TMI_870-WL(2)-01

Unique Identifier	Agency IR #	Annex	Agency / Group / Stakeholder	Cross Reference / Comment / Information Request / Response	
TMI_870-WL(2)-01	WL(2)-01	1	CEA Agency	Reference to EIS Guidelines:	Part 2, Section 9.1.2
				Reference to EIS / Appendix	Sections 5.9.2.1 - 5.9.2.4, Table 5.9.1; Appendix G; Section 9.1.2, Table 9.5, Figures 9.4 - 9.7; Appendix R Executive Summary, Section 2.2
				Cross-reference to Round 1 IRs	TMI_145-WL(1)-02, TMI_147-WL(1)-04, TMI_162-WL(1)-19, TMI_542-AC(1)-216
				<p>Context and Rationale:</p> <p>Ecosites</p> <ul style="list-style-type: none"> • The Agency requested a figure and summary table depicting the Project footprint components and ecosites. • However, the following issues were identified: <ul style="list-style-type: none"> ○ Figure 2a and 2b in TMI_145-WL(1)-02 includes white polygons which are not defined in the legend and appear to be used for both disturbed areas as well as undisturbed areas adjacent to Lola Lake. ○ Table 3 in TMI_145-WL(1)-02 does not include all wetland types identified in Appendix S. For example, WLD4, described as a wetland complex including swamp and marsh areas (Appendix S_Figure Vegetation Communities

**TMI_870-WL(2)-01_Figure 1b
Ecosites Within the Local Study Area**

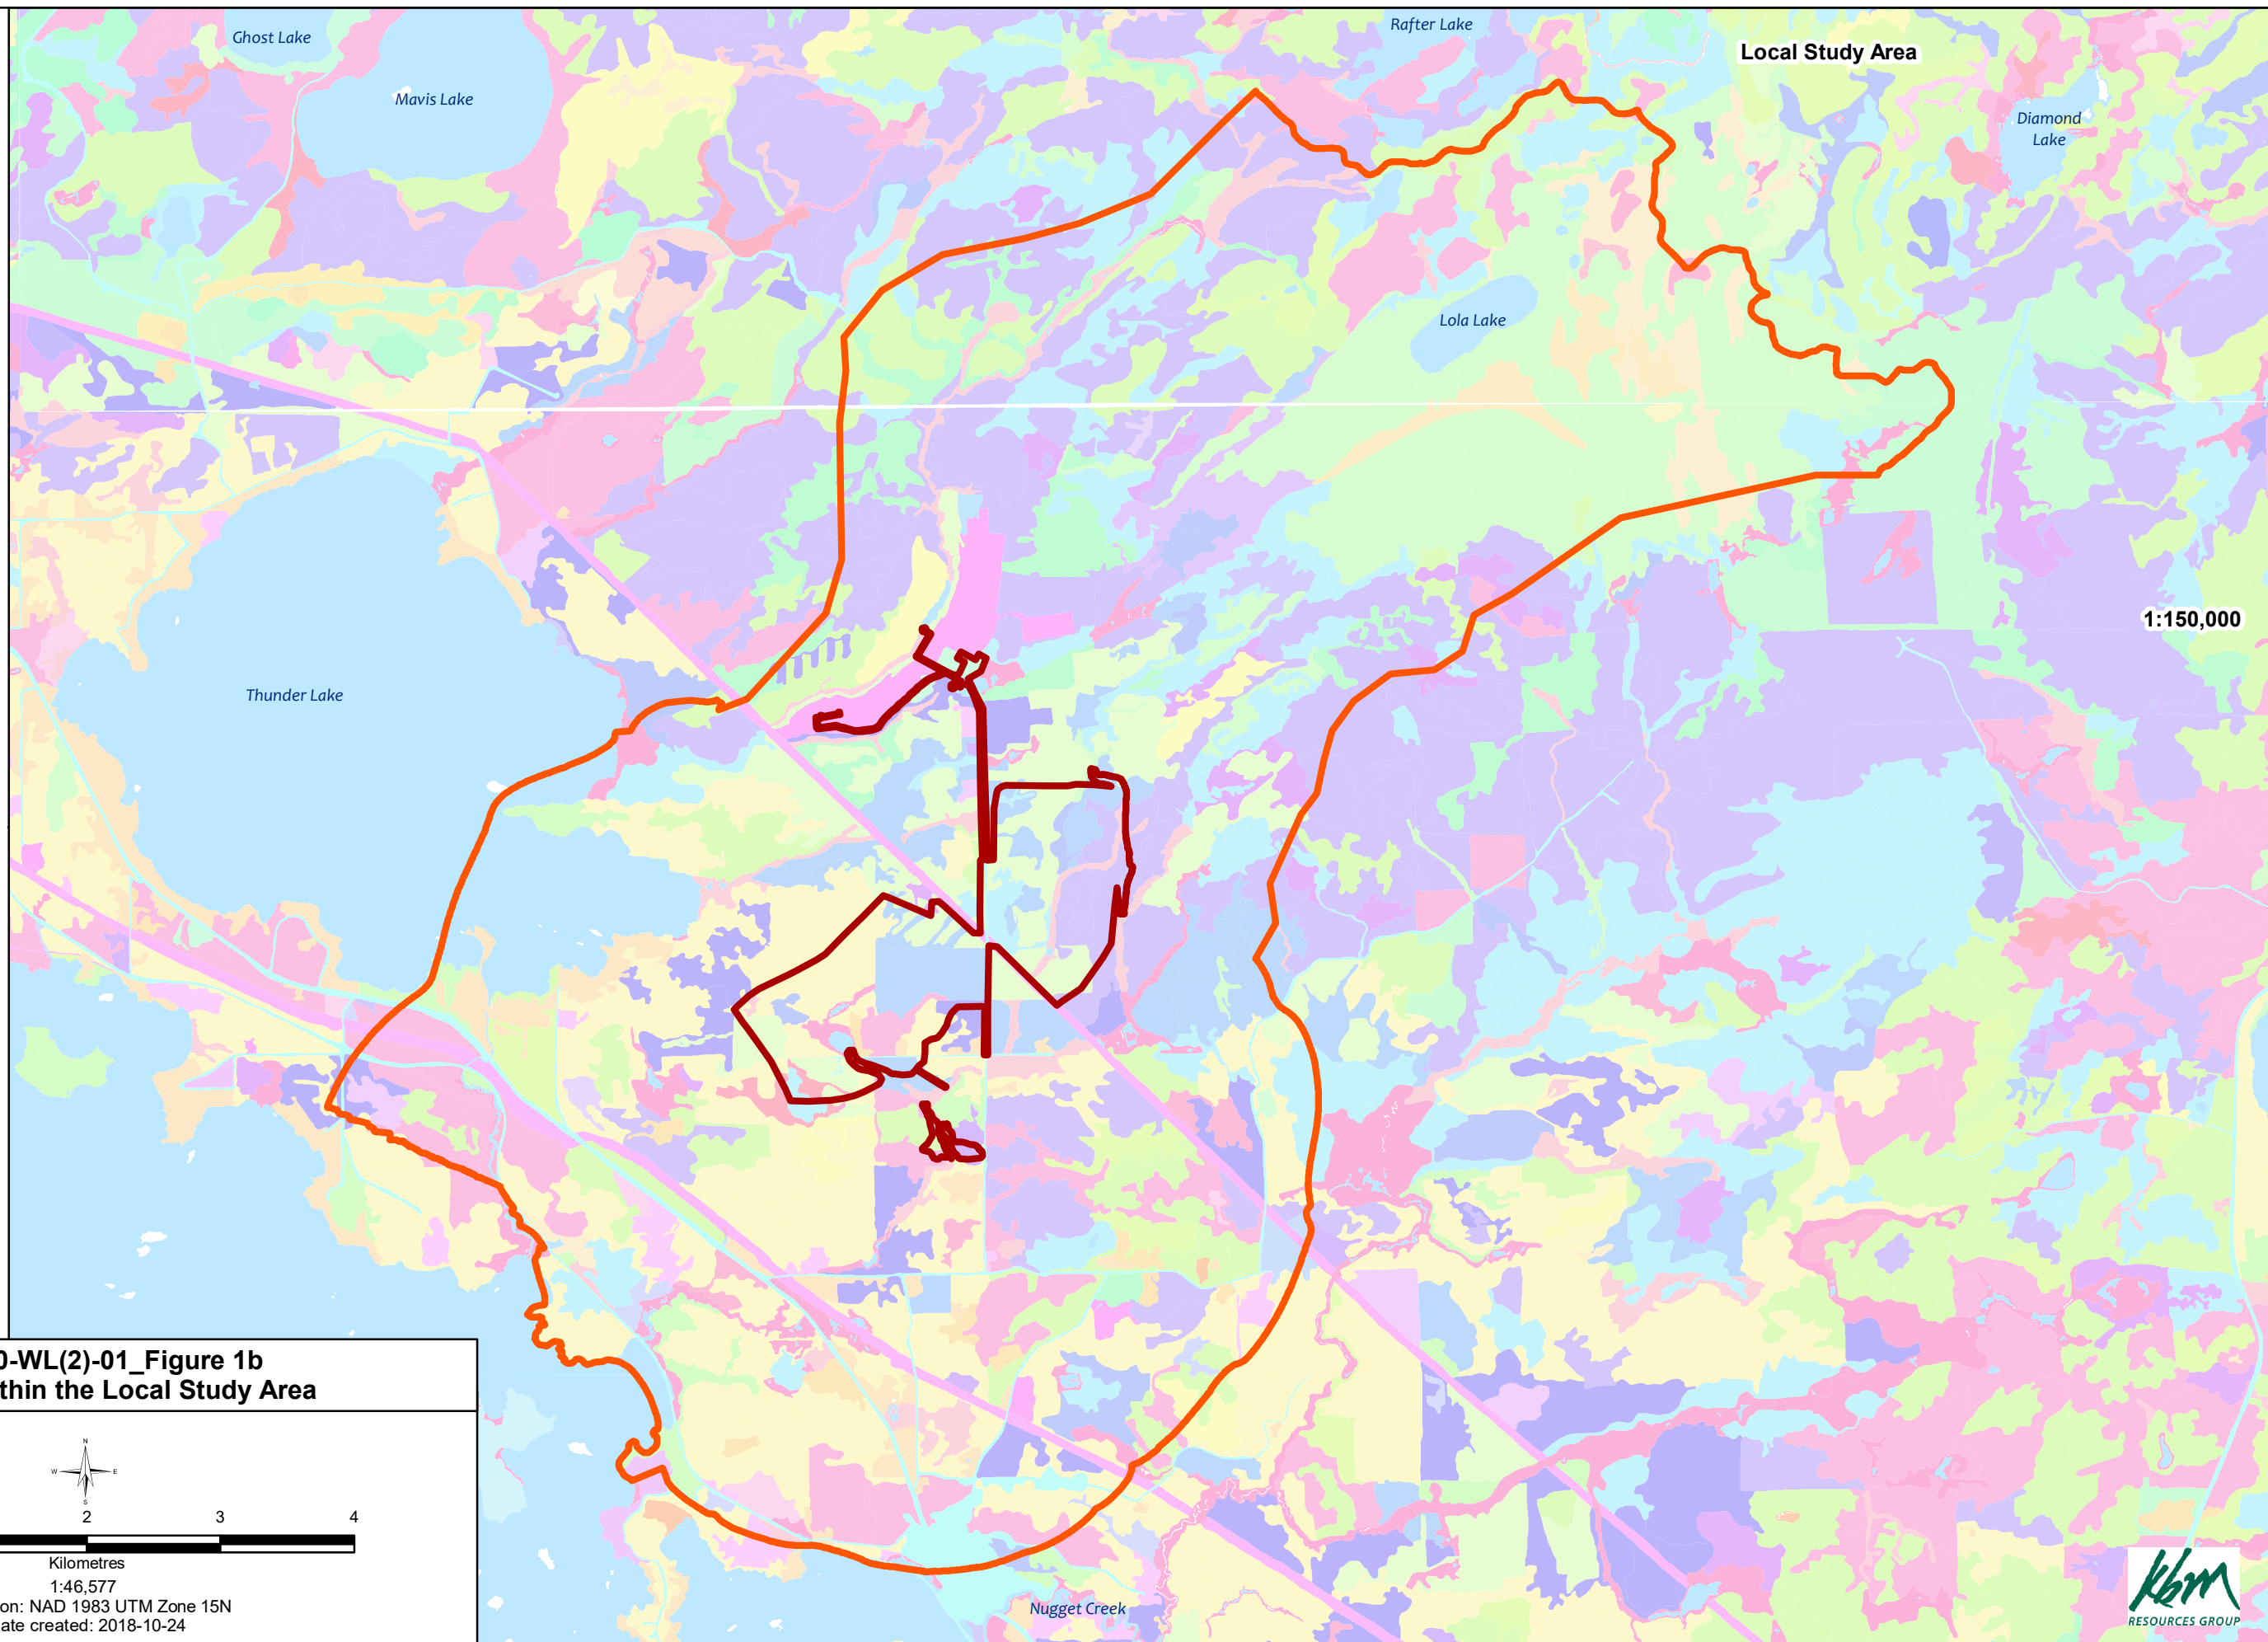
Unique Identifier	Agency IR #	Annex	Agency / Group / Stakeholder	Cross Reference / Comment / Information Request / Response
				<p><u>Part C:</u> An updated table summarizing the habitat loss contributed by the various Project elements has been presented in TMI_870-WL(2)-01_Table_3.</p> <p><u>Part D:</u> A new figure has been created to illustrate Habitat Classes and the Operation Area within the LSA (TMI_870-WL(2)-01_Figure 2). Corresponding habitat area summaries can be found in TMI_870-WL(2)-01_Table_1b.</p> <p><u>Part E:</u> Vegetation survey locations were summarized by Ecosite and Survey Area using the updated mapping in TMI_870-WL(2)-01_Table 4a, and by Habitat Class and Survey Area in TMI_870-WL(2)-01_Table 4b. This information was presented in two tables rather than a single table for clarity. Please note that ecosite is more ecologically relevant for assessing vegetation communities; habitat classifications were only used to assess wildlife. Please refer to the response to Question G for further discussion of these summary tables.</p> <p><u>Part F:</u> Appendix R Table 4.2 is unchanged with the changes in habitat classification. However, updated versions of Appendix R Tables 4.3 and 4.4 have been presented in TMI_870-WL(2)-01_Table 5a and 5b, respectively. TMI_870-WL(2)-01_Table_4a and TMI_870-WL(2)-01_Table_4b supersede the table include in the response for TMI_147- WL(1)-05. Additionally, TMI_870-WL(2)-01_Table 5b supersedes TMI_162 WL(1)-19 Tables 5 and TMI_870-WL(2)-01_Table 1b supersedes TMI_162 WL(1)-19 Tables 10.</p> <p><u>Part G:</u> Breeding Birds Breeding bird survey areas by habitat class have been presented in TMI_870-WL(2)-01_Table_6; a deficiency in surveyed Swamp – Coniferous and Fen habitat was identified. However, given that the request for updated habitat classifications was communicated on June 8th, the ecosite-habitat classification correlations were finalized on June 15, the need for additional surveys was communicated on June 29th, and the breeding bird survey window closed on July 7th, it was not reasonably feasible to mobilize and conduct the necessary bird surveys using the specified methodology during the 2018 field season. Further, Treasury Metals would have been unable to attain a permit to work in Lola Lake Nature Reserve within this window. Through discussions with ECCC, it was decided that any perceived deficiencies in sampling effort can be addressed through the construction-operations phase monitoring program in lieu of conducting further baseline surveys (correspondence has been included in TMI_870-WL(2)-01_Appendix_A).</p> <p>Vegetation The initial vegetation surveys were planned and executed to reflect the original ecosite mapping (i.e., NWO Ecosite classifications), which is coarser than the provincial ecosite classifications that were used to develop the updated habitat categories. As such, the existing surveys no longer capture all ecosites within the LSA. There were difficulties transitioning the existing survey locations, as the provincial ecosite landcover data now indicates that a disproportional number of surveys were conducted in disturbed areas (Ecosite B197) and some survey locations now appear as</p>

Unique Identifier	Agency IR #	Annex	Agency / Group / Stakeholder	Cross Reference / Comment / Information Request / Response
				<p>though they were conducted in open water, both of which are incorrect. Ecosite code were assigned to survey locations appearing within open water where reasonable inferences could be made, or they were omitted from the summary table (i.e., TMI_870-WL(2)-01_Table 4a and 4b).</p> <p>These are artefacts of updating the ecosite mapping 7 years after the initiation of baseline data collection, and not a reflection of the quality of the work. Treasury Metals is confident that the existing vegetation surveys adequately captures the natural variation of the Boreal forest, which is relatively simple and homogenous in the Project area.</p> <p><u>Part H:</u> Breeding bird summaries have been updated in TMI_870-WL(2)-01_Table 5a and 5b and TMI_870-WL(2)-01_Table_6 (see parts F and G of this response). Vegetation summaries have been updated in TMI_870-WL(2)-01_Table 4a and 4b.</p> <p><u>Part I:</u> Projected densities by habitat type were calculated for all species observed through the breeding bird surveys. These densities were then used to determine how many individuals of each species are expected to be displaced by the development of the Operations Area. This information is summarized in TMI_870-WL(2)-01_Table_7. Please note that, although TMI_870-WL(2)-01_Table 7 indicates that 12 Barn Swallows will be displaced by the Project, no potential nesting habitat (i.e., existing buildings and anthropogenic structures) are going to be removed as a result of the Project. This value simply reflects the number of Barn Swallows that are expected to forage within the Operations Area, and are likely to continue doing so during the life of the Project. Likewise, the development will not remove potential Bald Eagle nesting habitat, as reflected in the previously submitted response to TMI_153-WL(1)-10.</p> <p><u>Part J:</u> The changes to habitat mapping do not change the effects assessment presented in the revised EIS.</p> <p><u>Part K:</u> No changes are necessary to the mitigation measures/monitoring plan presented in the revised EIS.</p> <p>References: Government of Ontario. Land Information Ontario. https://www.ontario.ca/page/land-information-ontario</p> <hr/> <p>Agency Comment on Draft Response:</p> <p>TMI #: The Agency has reviewed TMI_870-WL(2)-01_Figure_1a and TMI_870-WL(2)-01_Figure_1b, and has three comments.</p> <p>A1. The Agency notes that these figures present an “Operations Area.” TMI_871-WL(2)-02_Figure 2b shows an “Operations Area” and a separate “Project Footprint.” As presented in TMI_913-REC-01, the Agency requests the proponent create a “Project Study Area” that includes all project components within the boundary, including but not limited to the following:</p>

The initial vegetation surveys were planned and executed to reflect the original ecosite mapping (i.e., NWO Ecosite classifications), which is coarser than the provincial ecosite classifications that were used to develop the updated habitat categories. As such, the existing surveys no longer capture all ecosites within the LSA (TMI_870-WL(2)-01_Table_4). There were difficulties transitioning the existing survey locations, as the provincial ecosite landcover data now indicates that a disproportional number of surveys were conducted in disturbed areas (Ecosite B197) and some survey locations now appear as though they were conducted in open water. Adjustments were made to using

Unique Identifier	Agency IR #	Annex	Agency / Group / Stakeholder	Cross Reference / Comment / Information Request / Response
				<p>field observations, satellite imagery and FRI data as a guide. These were artefacts of updating the ecosite mapping with FRI data from LIO, and not a reflection of the quality of the work. Treasury Metals is confident and it is the professional opinion of their independent consultants that the existing vegetation surveys adequately captures the natural variation of the Boreal forest, which is relatively simple and homogenous in the Project. TMI is confident and it is the professional opinion of their independent consultants that the updated ecosite and habitat mapping for the PSA, LSA and RSA is correct.</p> <p>Wildlife and SAR</p> <p>Extensive work has been conducted to identify the species likely to occur within the PSA and LSA, and the habitats present in both study areas. All applicable MNRF-approved survey protocols have been employed targeting these species/communities over 7 field seasons. Updated effects assessments for wildlife, SAR and VCs of interest to Indigenous groups have been provided in TMI_870-WL(2)-01_Table_9, TMI_952-WL(2)-07_Table_2, TMI_952-WL(2)-07_Table_4, respectively. Treasury Metals is confident and it is the professional opinion of their independent consultants that all wildlife species, except for migratory birds (discussed below), have been sufficiently surveyed.</p> <p>Migratory Birds</p> <p>Breeding bird survey areas by habitat class have been presented in TMI_870-WL(2)-01_Table_6 for the PSA, LSA and RSA; a clear deficiency in surveyed Fen habitat was identified. However, given that the request for updated habitat classifications was communicated on June 8th, the ecosite-habitat classification correlations were finalized on June 15, the need for additional surveys was communicated on June 29th, and the breeding bird survey window closed on July 7th, it was not reasonably feasible to mobilize and conduct the necessary bird surveys using the specified methodology during the 2018 field season. Further, Treasury Metals would have been unable to attain a permit to work in Lola Lake Nature Reserve within this window, with the clear majority of Fen habitat within the LSA falling within the park. Through discussions with ECCC, it was decided that any perceived deficiencies in sampling effort can be addressed through the construction-operations phase monitoring program in lieu of conducting further baseline surveys (correspondence has been included in TMI_870-WL(2)-01_Appendix_A). Please refer to TMI_873-WL(2)-04 for a discussion of monitoring programs.</p> <p><u>Part H:</u> Treasury Metals has completed the tables sent by the Agency to include wildlife habitat summaries as well as for breeding birds. Please refer to TMI_870-WL(2)-01_Table_1 and TMI_870-WL(2)-01_Table_4 for vegetation, TMI_871-WL(2)-02_Table_3 for wetlands, TMI_870-WL(2)-01_Tables 5-8 for migratory birds, TMI_952-WL(2)-07_Table_2 for Species at Risk, TMI_952-WL(2)-07_Table_4 for species/communities of interest to Indigenous groups, and TMI_870-WL(2)-01_Table_9, TMI_870-WL(2)-01_Table_10 and TMI_870-WL(2)-01_Table_11 for all terrestrial biology VCs presented in the revised EIS.</p> <p><u>Part I:</u> Projected densities by habitat type were calculated for all migratory bird species (Government of Canada 1994) observed through the breeding bird surveys TMI_870-WL(2)-01_Table_7. These densities were then used to</p>
